SERVICE BULLETIN

INSTALLATION OF REDUCED NOISE EMISSION MUFFLER FOR ROTAX® ENGINE TYPE 914F (SERIES) SB-914-006 R1

SB-914-006

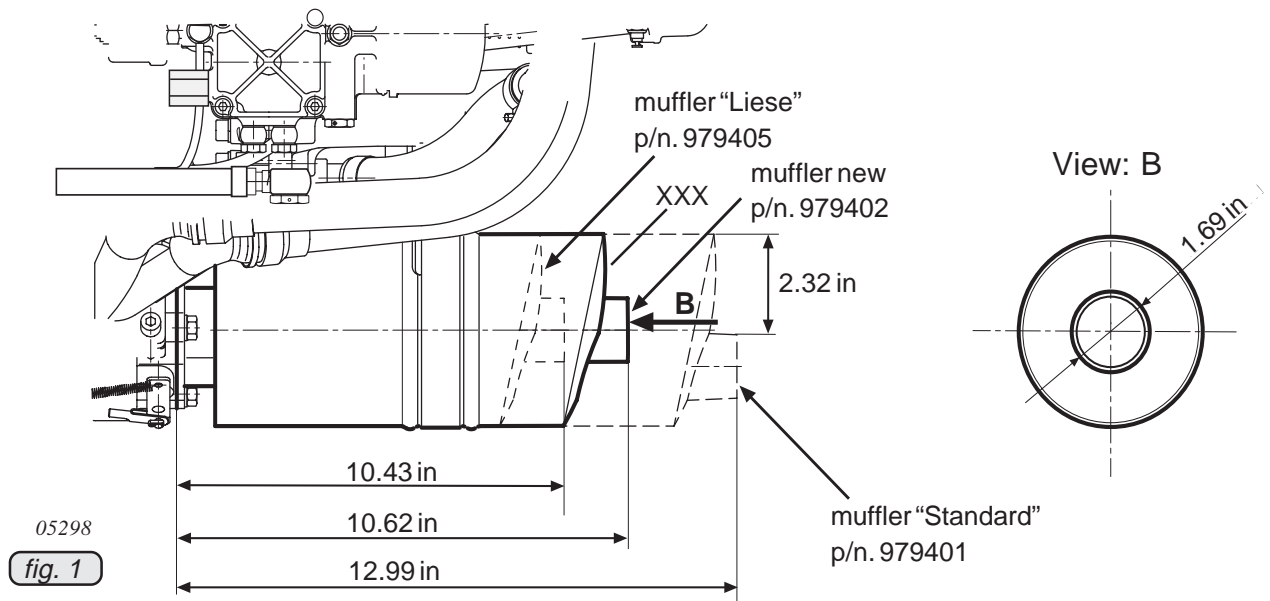
- Weight: weight reduction of approx. 300g
- Outline dimensions: The difference is the overall length of the muffler. Length reduction from 330 mm (12.99 in.) (standard muffler part no. 979401) to 270 mm (10.63 in.) (part no. 979402), see fig. 1. Be careful to consider the changed exhaust tail pipe position.

- Weight: weight reduction of approx. 30g
- Outline dimensions: The difference is the overall lenght of the muffler. Length increase from 265 mm (10.43 in.)(standard muffler part no. 979405) to 270 mm (10.63 in.)(part no. 979402), see fig. 1. Be careful to consider the changed exhaust tail pipe position.

- Installation of the new muffler (part no. 979402) as per Maintenance Manual 914 F, chapter 13.5.3.
- Visual check of engine. See Maintenance Manual 914 F, chapter 12.3.2.
- Restore aircraft to original operating configuration.
- Connect negative terminal of aircraft battery.
